Product Change Notification (PCN)

PCN #: 7D-2025 Date: July 15, 2025

Ezurio Part Number	Description
453-00001-K1	Development Kit, Module, BL54L15, Trace ANT
453-00044-K1	Development Kit, Module, BL54L15, MHF4

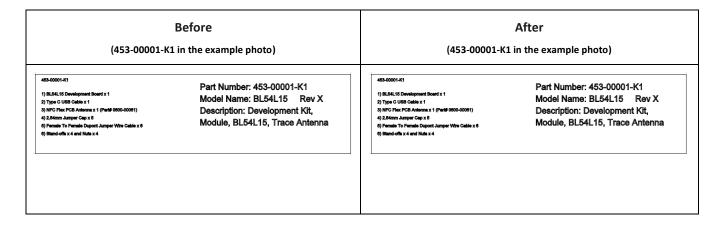
Replace the U11 TI level shifter with TXS0102DCU and non-populate R10, R11, R12, R27.

The mikroBUS connector is at 3.3V, therefore a level shifter is used in the BL54L15 DVK design to convert 3.3V to 1.8V. The original design used a TI level shifter (U11, TXB0102DCUR) which will not work with open drain IO on the PWM and INT pins of the mikroBUS adaptor. Changing the level shifter U11 to TXS0102DCU will improve the compatibility with mikroBUS devices.

Remove R10, R11, R12, and R27. These resistors were pull-downs on the LEDs. The LED IOs are shared with the mikroBUS adapter. Pull-down resistors can interfere with mikroBUS operation.
